RELEVANT INFORMATION FOR COUNCIL

FILE: D/2015/1286 **DATE:** 21 October 2016
TO: Lord Mayor and Councillors
FROM: Louise Kerr, Acting Director City Planning, Development and Transport
SUBJECT: Information Relevant To Item 9.8 – Development Application: 256-262 Mitchell Road, Alexandria - At Council - 24 October 2016

Figure 3: reduction in the size of Unit 304 (at the rear of the development facing Belmont Lane)

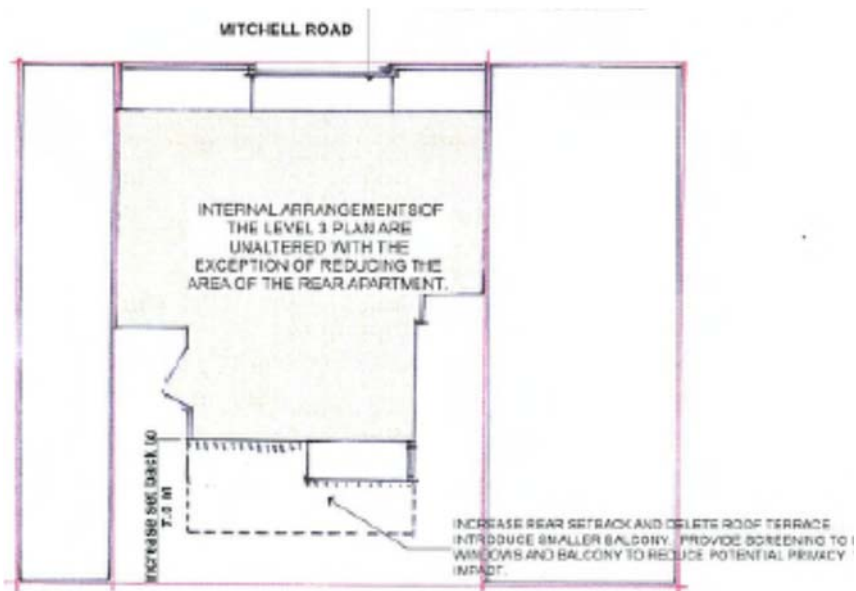
- *The roof projection to Mitchell Road is oversized and dominates the building elevation. The up-turned roof pitch and gable at the roof edge, exacerbates this perception from street level. The roof should be re-scaled and setback;*
- *Upper floors facing the west (actually the east) should be set-back further to reduce overshadowing and limit views into neighbouring adjacent properties to the south-east; and*
- *The Mitchell Road elevation is currently composed of aluminium sliding screens and glass balustrades. The panel suggested a masonry response would be a better contextual fit for the site.*

- Increasing the setback of the rear topmost floor (Unit 304) to 7.5 metres relative to the Belmont Lane boundary (see **Figure 3**). This results in Unit 304 being a 77sqm 2 bedroom unit down to a 53sqm 1 bedroom unit. The unit mix would now be 15 x 1 bedroom and studio apartments and 3 x 2 bedroom apartments;
- The terrace associated with unit 304 will also be replaced with a smaller balcony and additional screening will be added to its eastern elevation to further minimise overlooking into the residential properties on the opposite side of Belmont Lane;
